# CITY OF ALBUQUERQUE

October 12, 2022

**RE: Griegos Farms  
Conceptual Grading & Drainage Plans  
Engineer's Stamp Date: 09/01/22  
Hydrology File: F13D028A**

Based upon the information provided in your submittal received 09/01/2022, the Conceptual Grading & Drainage Plans are preliminary approved for action by the DRB for Site Plan for Building Permit and Platting action.

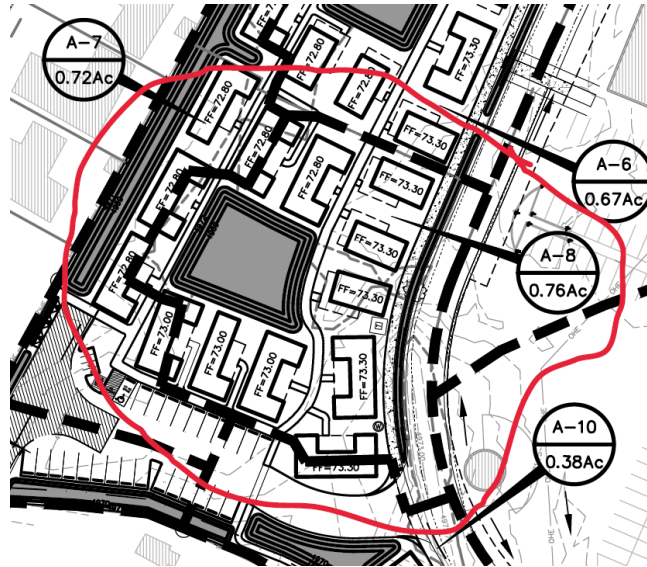
1. Provide more detailed design as needed in order to obtain Hydrology's approval.
2. Please ensure that each drainage area's retention pond volume provides at least the required volume for that drainage area unless it drains into another pond. For example, Drainage Area A-5 requires 9150 cubic feet but only 5700 CF is provided. Now Drainage Area A-8 requires 7642 CF and the provided volume is 12425 CF. Unless these two ponds are connected, the missing volume in A-5 cannot be compensated in A-8 without some sort of equalizing pipe system. If a drainage area fails to provide for the drainage volume requirement, then it has a potential to drain into the adjacent property which is not allowed.
